Assessment Ride Notes Nanaimo Street

Ride held January 19, 2019
Vancouver UBC Local Committee, HUB Cycling

Figure 5 - Nanaimo Street near Venables

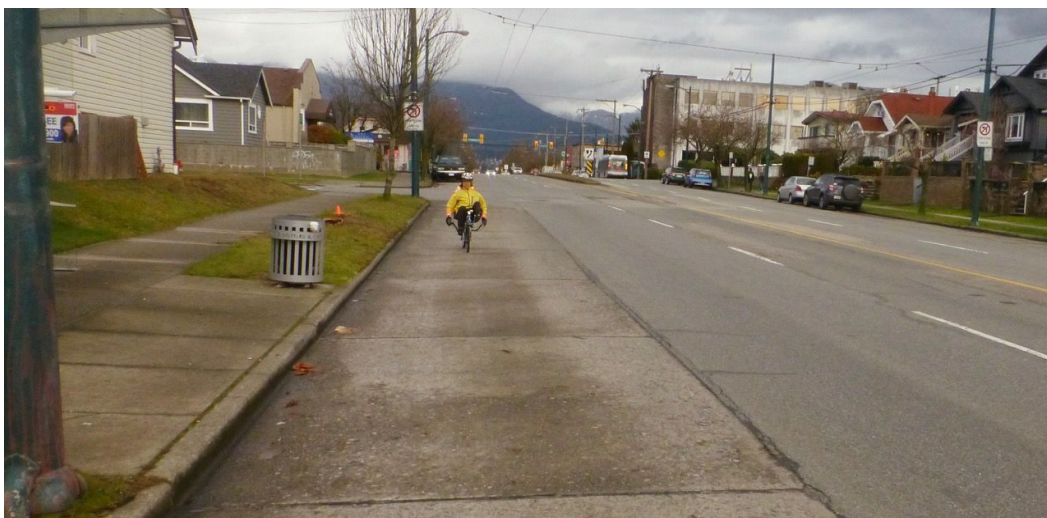
The asphalt is fine. The concrete needs a bit of grinding in spots.
